IMPACT GUARD RETROFIT & UPGRADE NOTICE

HOIST LINE TENSION LIMITER

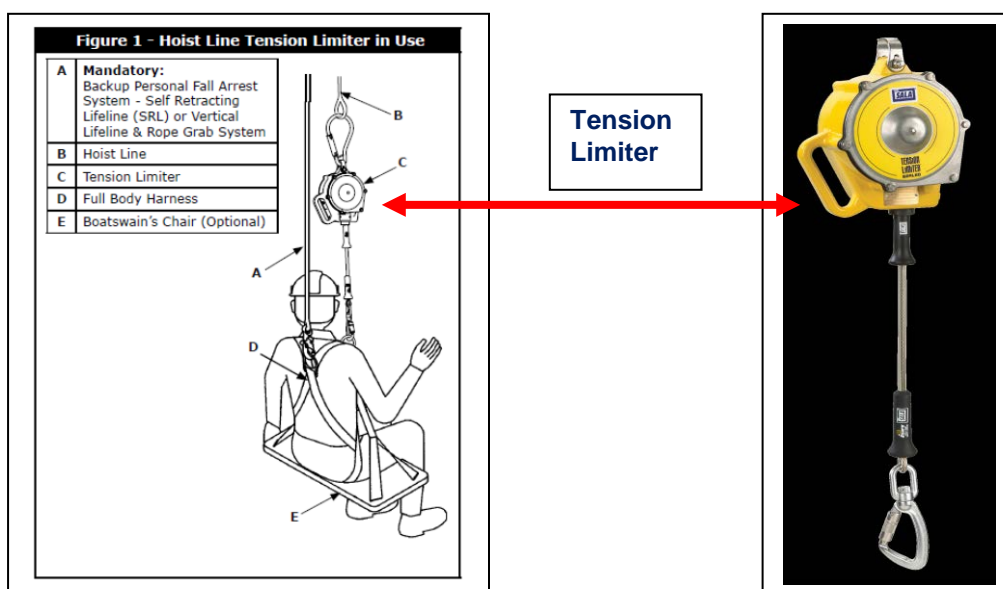
The DBI-SALA Hoist Line Tension Limiter (model #3601490), connects in line between the suspended worker and the winch line. If the worker becomes entangled in a fixed object, the Tension Limiter deploys a bright yellow cable intended to alert the winch operator to stop. When the Tension Limiter deploys, it limits the load on the worker to reduce the possibility of severe injury. A Tension Limiter is not a fall protection system. A backup personal fall arrest system (such as an SRL) must always be used in conjunction with a Tension Limiter (see figure 1).

Capital Safety has received a very limited number of reports of inadvertent damage to Tension Limiters during use. Specifically, during ascent, if the Tension Limiter impacts and is trapped by a fixed object while under load from the winch, it is possible that the force applied to the unit by the winch can damage the face plate and housing bolts of the unit. In extreme cases under excessive load, the face plate may be ripped off the unit. In such an event, the resulting damage to the unit can create a risk of injury to the user or workers below. To eliminate the potential for the unit to be damaged as described above, Capital Safety has developed a retrofit kit in the form of an Impact Guard for the Tension Limiter.

The attached single page instruction sets out a very simple procedure for installing the Retrofit Kit. The installation process requires replacement of only two housing bolts and can easily be completed in less than five minutes. Installation of the Impact Guard does not affect the operation of the Tension Limiter.
